**Subject:** Submittal of Replacement Pages to Update the NAC-UMS<sup>®</sup> FSAR from Revision 4 to Revision 5 (Docket No. 72-1015)

**10 CFR 72.48 Evaluation Summary Report**

**NAC-UMS<sup>®</sup> Universal Storage System  
(Docket No. 72-1015)**

<b>NAC INTERNATIONAL</b>		
FUEL CAN DETAILS MAINE YANKEE (MY) NAC-UMS®		
PROJECT 412	DRAWING 502	REV 6
SCALE FULL	REVISION NOTED	SH 4 OF 6

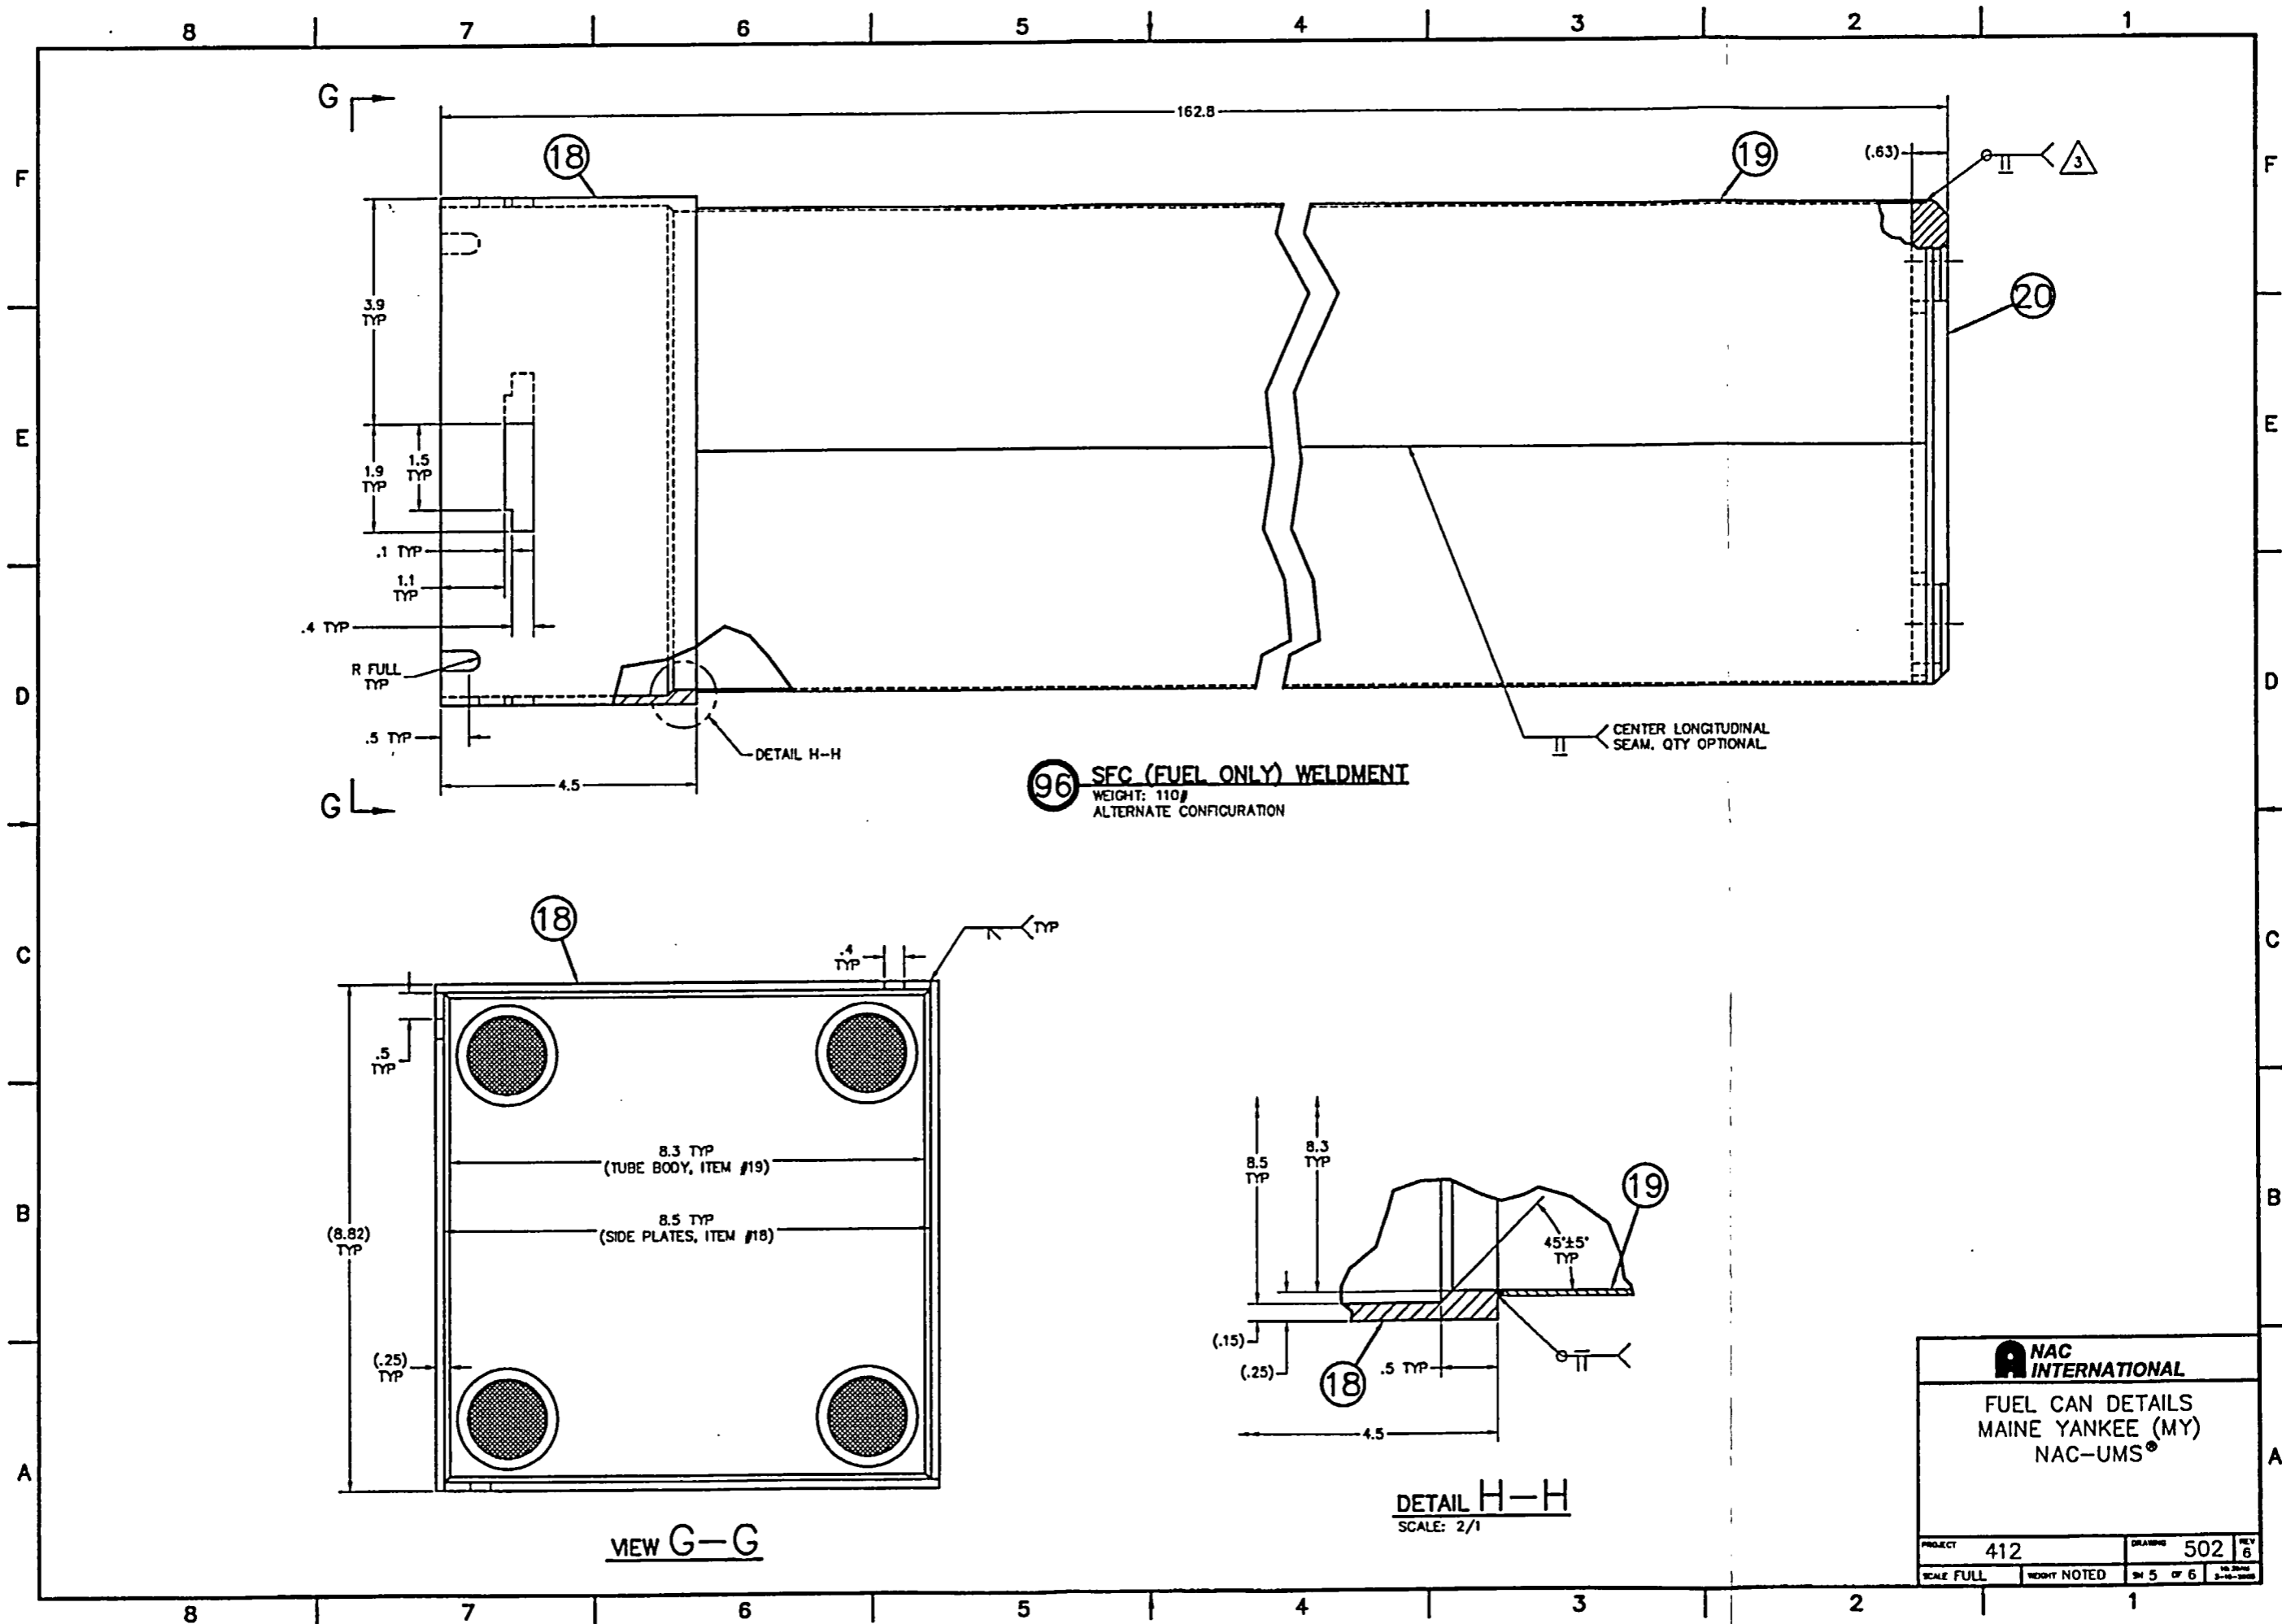
1. Added Delta Note 10 to Item 4, Wiper, "Minor edge surface and/or dimensional deviations are acceptable for Item 4, Wiper."
2. Deleted Detail B-B and callout on Sht 4 of 6, Zone A3 & D1.

The wiper is used to ensure that particles from damaged fuel assemblies stay inside the damaged fuel can. The surface finish and the exact profile/shape of the edge are not critical, so long as the wiper fills the gap between the damaged fuel can and the damaged fuel can lid to block that escape path. These changes have no impact on the performance of each component and/or the overall system functionality. With this DCR(L), the drawing will bound all the final as-built conditions noted in the site documentation packages for the Maine Yankee project.
